Brewers Hill H.D.

Certificate of Appropriateness

Property 113 W. VINE ST.
Description of work 10-foot addition to back of house for a new kitchen and closet.
Date issued 8/28/2007

PTS ID 44664 COA - House Addition

113 W VINE WEST VIEW

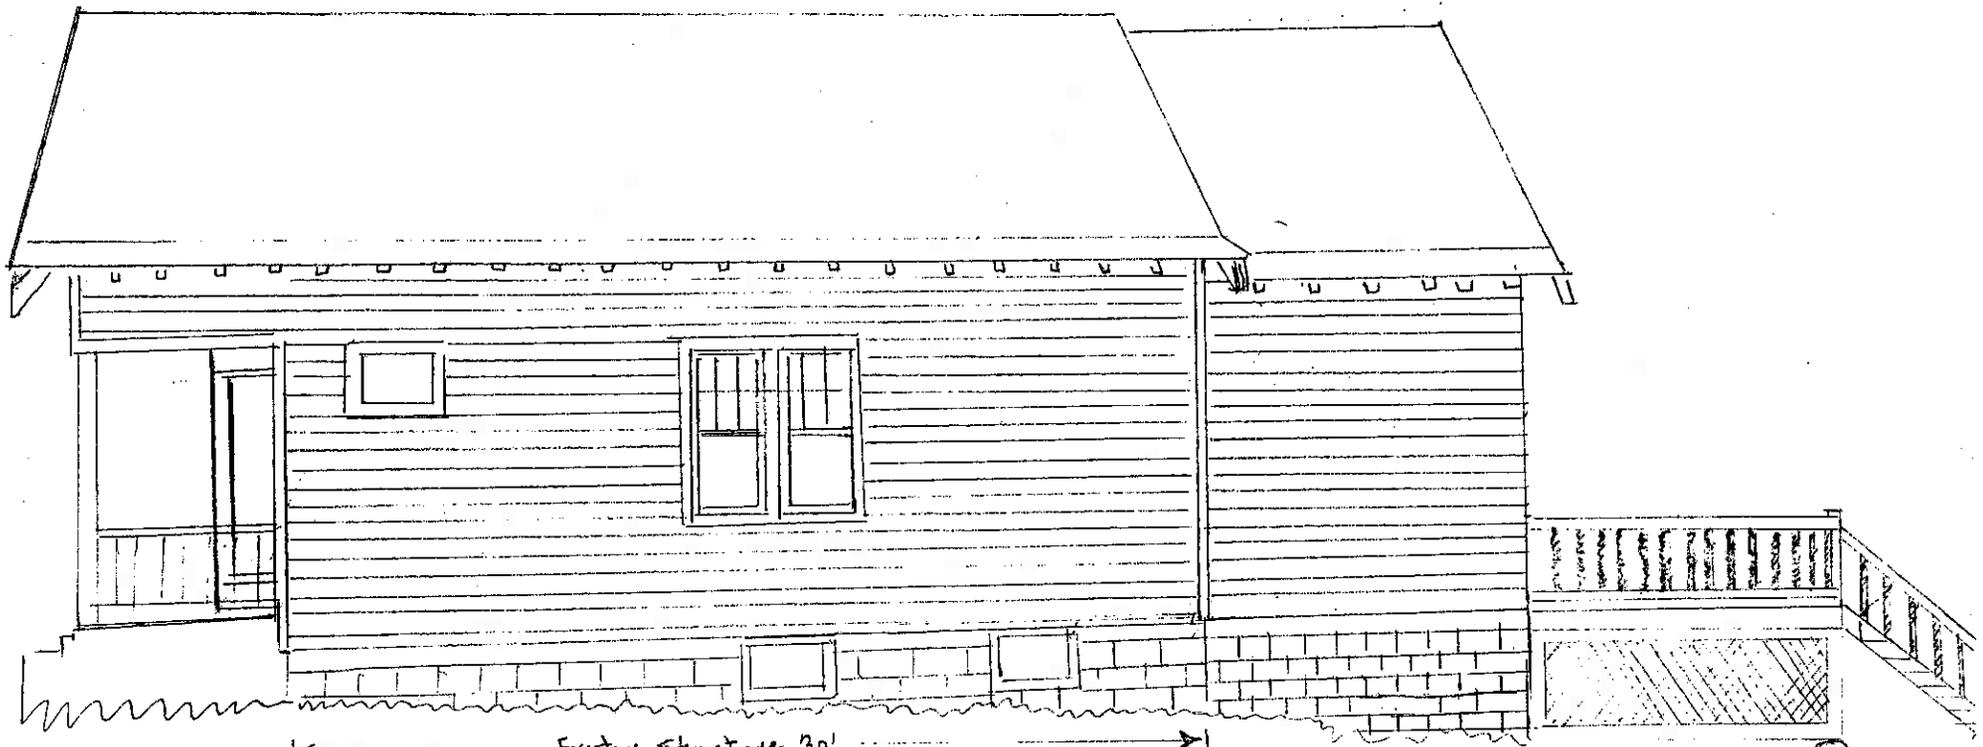
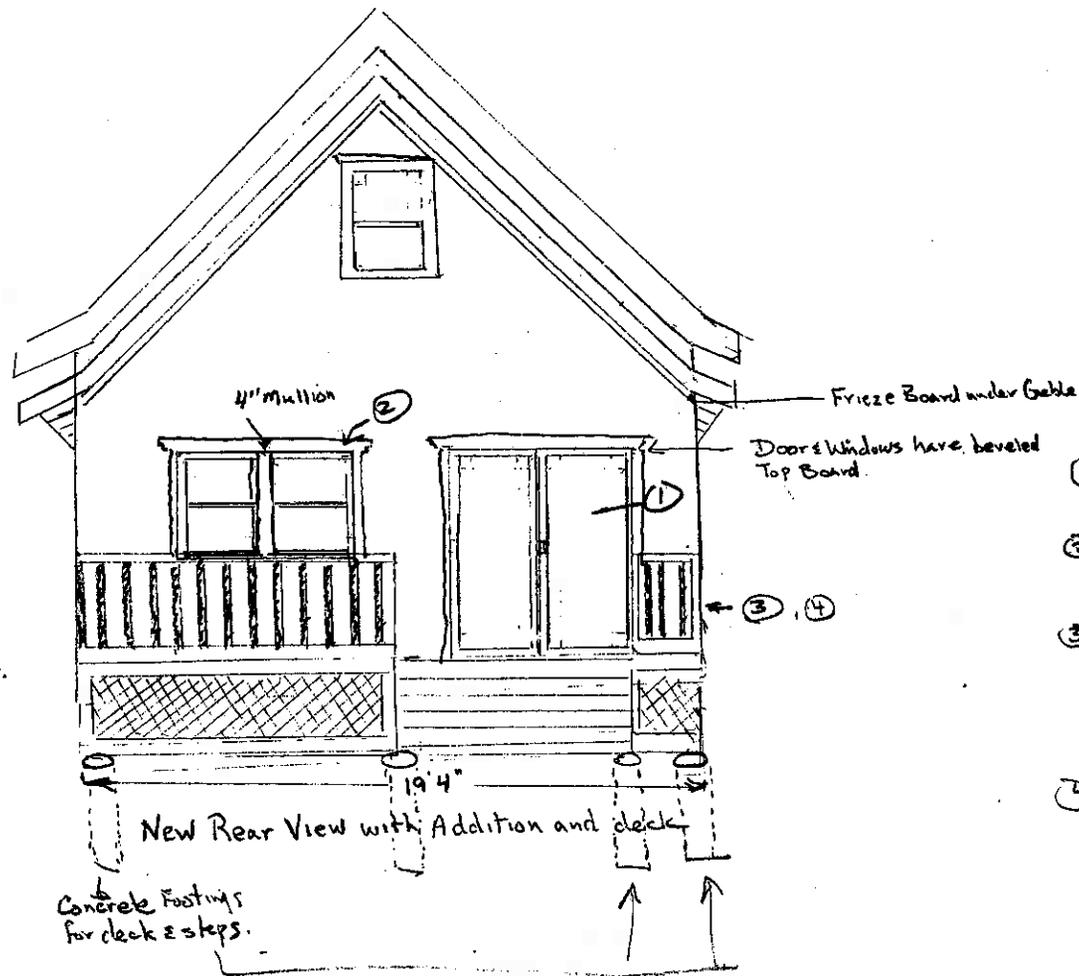
Balusters must be 3-1/2" on center. Note detail sheets for railings, corner boards, water table and newels.

Balusters
 $3\frac{1}{2}$ " o.c.

Note detail
 sheets attached
 for Railings,
 corner boards,
 water table &
 Newels.

Porch Skirting

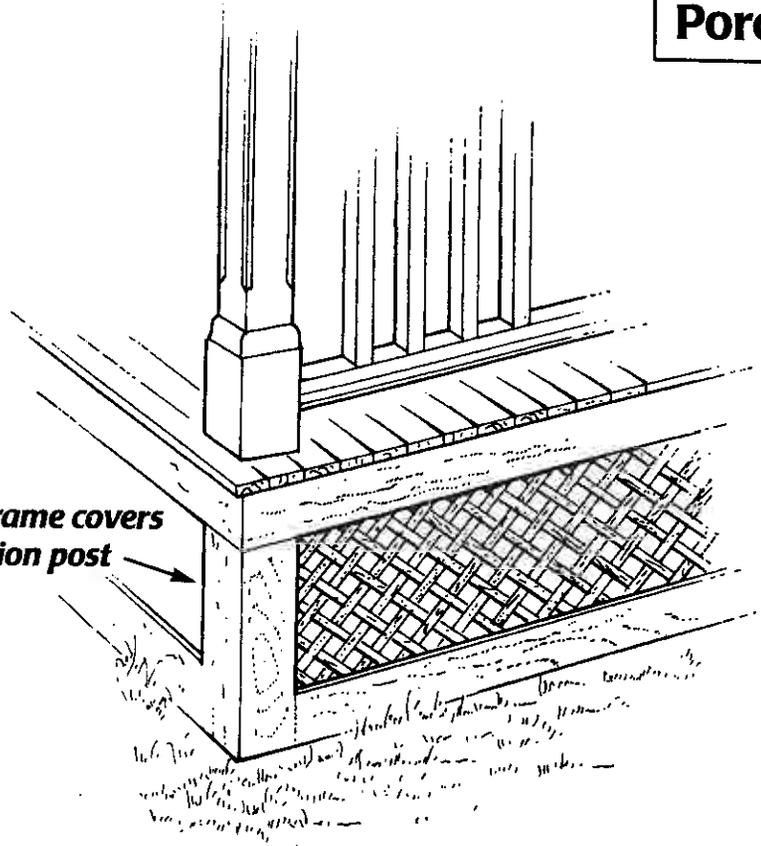
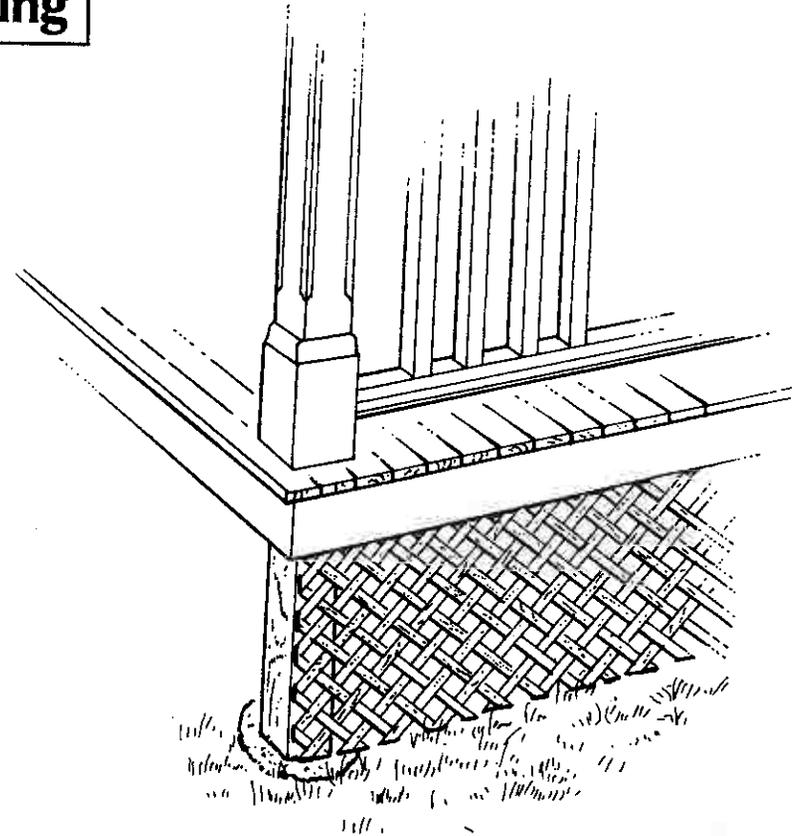
Skirting, such as this lattice panel, enclosed the area beneath the porch floor. It should always be installed with a continuous board frame around it that is wide enough to cover the rough framing lumber that supports the porch deck.

Do not install a lattice skirting without a frame around it. The rough framing lumber that supports the porch will show through and the raw edges of the lattice look unfinished.

HANDRAIL/GUARDRAIL SECTION FULL SIZE

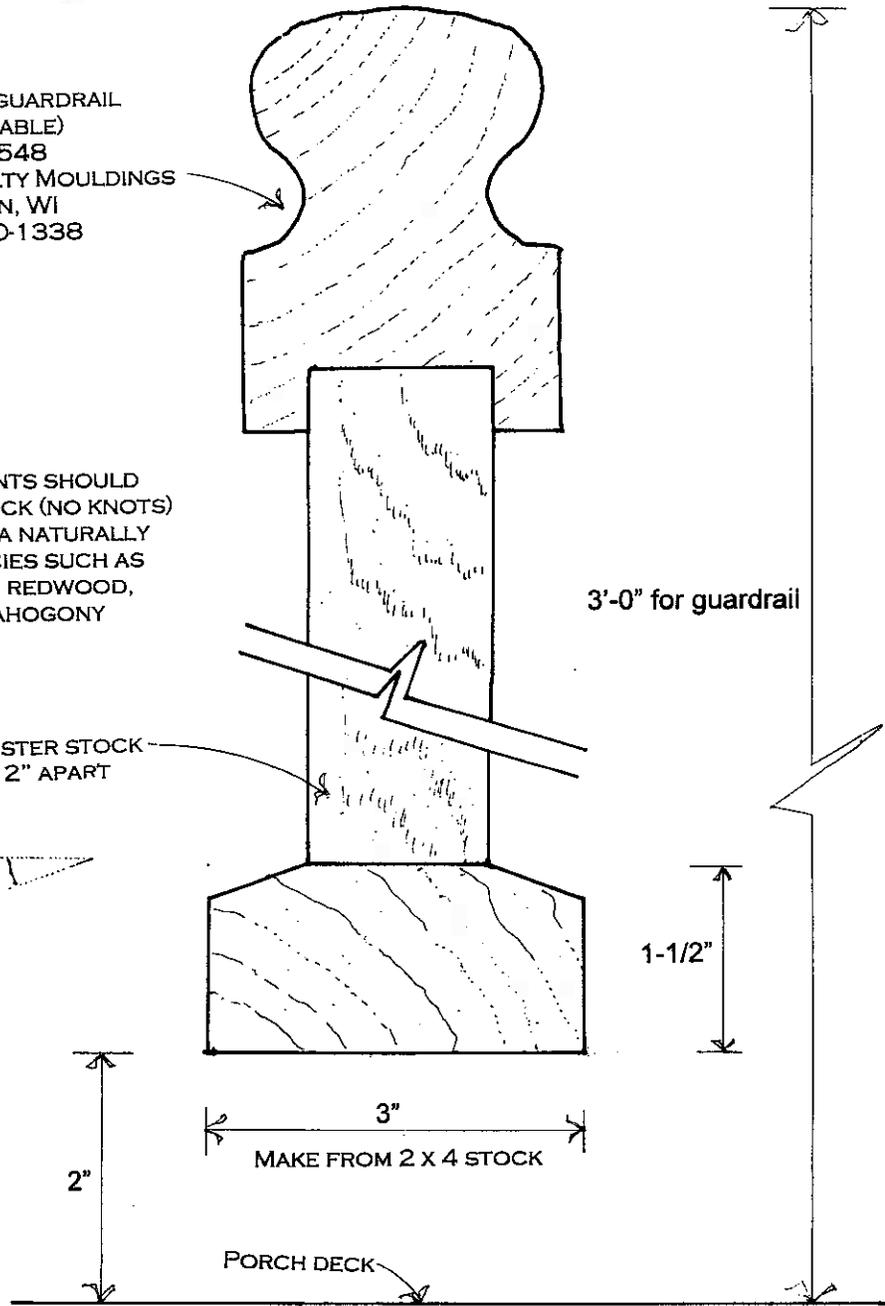
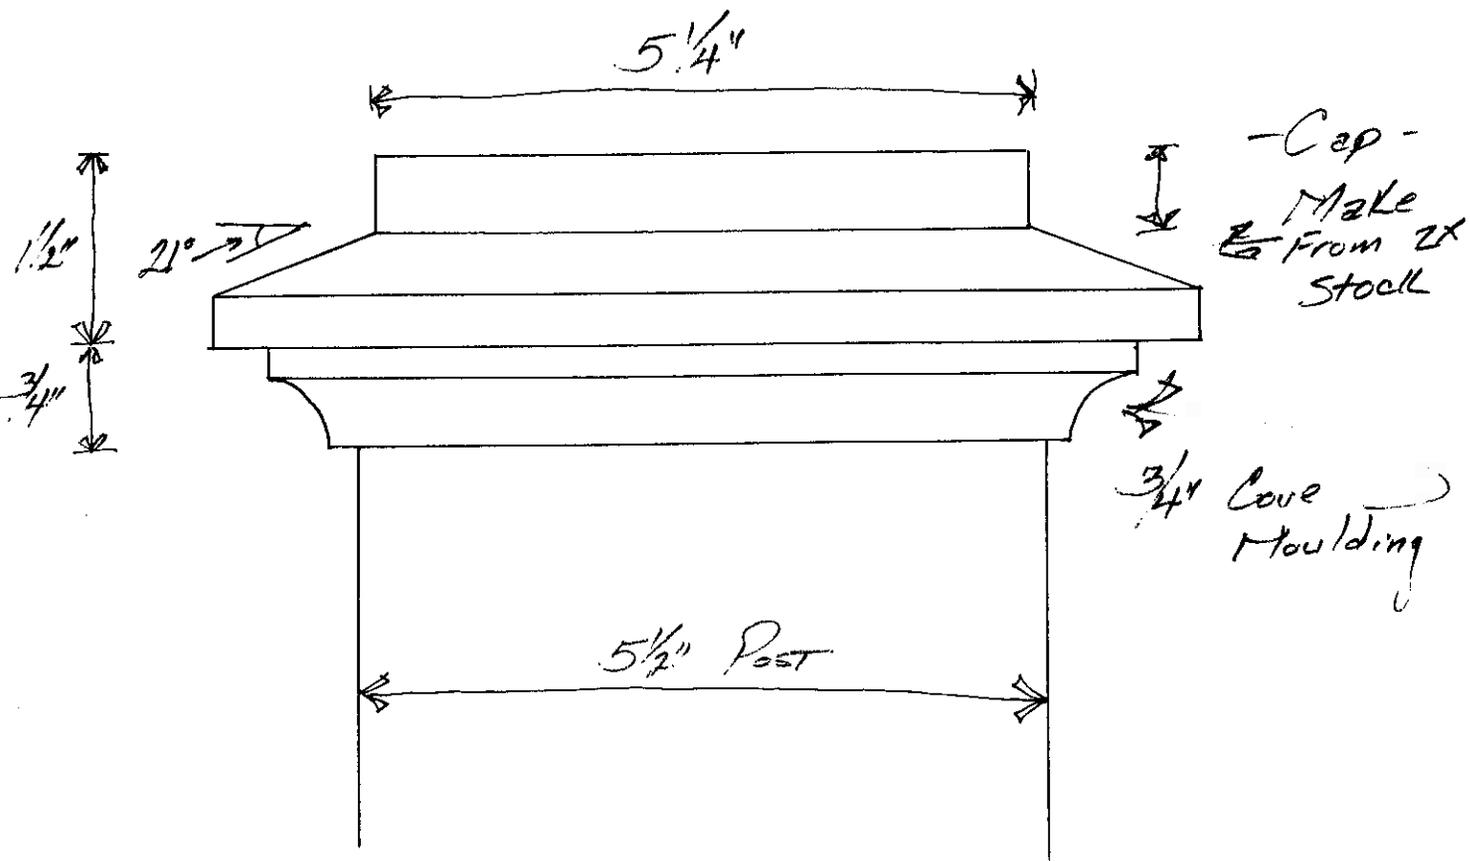
ALL RAILING COMPONENTS SHOULD
BE MADE FROM CLEAR STOCK (NO KNOTS)
AND PREFERABLY FROM A NATURALLY
DECAY-RESISTANT SPECIES SUCH AS
RED CEDAR, CYPRESS, REDWOOD,
SPANISH CEDAR, MAHOGONY

2 x 2 BALUSTER STOCK
SPACED 2" APART

**WATER TABLE
AT TOP OF FOUNDATION**

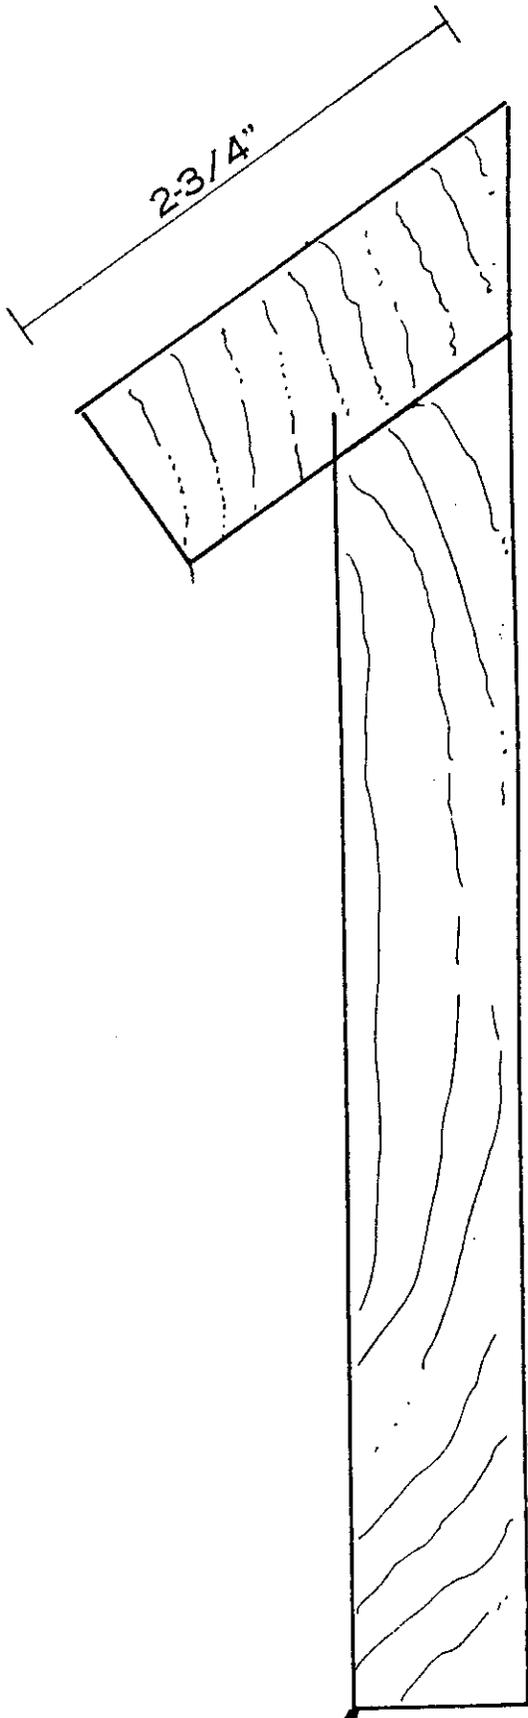
NOTE: $1\frac{3}{16}$ " OR $\frac{3}{4}$ " MATERIAL
MAY BE USED FOR ANGLED BOARD
